**DEPARTMENT OF HEALTH AND HUMAN SERVICES
FOOD AND DRUG ADMINISTRATION
CENTER FOR DEVICES AND RADIOLOGICAL HEALTH**

Subject: P070008/S015
Biotronik, Inc.
Corox OTW-L BP Left Ventricular Pacing Lead

Recommendation: **Approval**

Figure 1. The Corox OTW BP family of LV leads (from left to right): the proposed Corox OTW-L BP, the market-approved Corox OTW-S BP, and the market-approved Corox OTW BP leads.

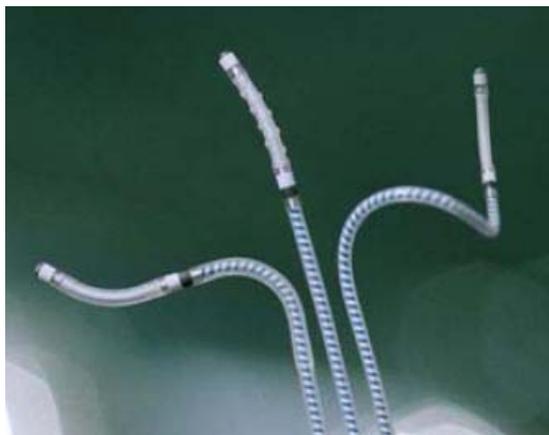
This PMA supplement was submitted to gain approval for an additional left ventricular pacing lead in Biotronik's Corox OTW BP family of leads. The firm states on page 3 of the submission that the lead is identical to legally-marketed Corox OTW BP leads with the following exceptions that are intended to provide the physician with another option of shape and fixation method for different vessel anatomies:

1. Modification to the shape of the distal end of the lead
2. Extension of the polyurethane tubing by 3 mm
3. (b) (4) silicone molded parts of the fixation tip
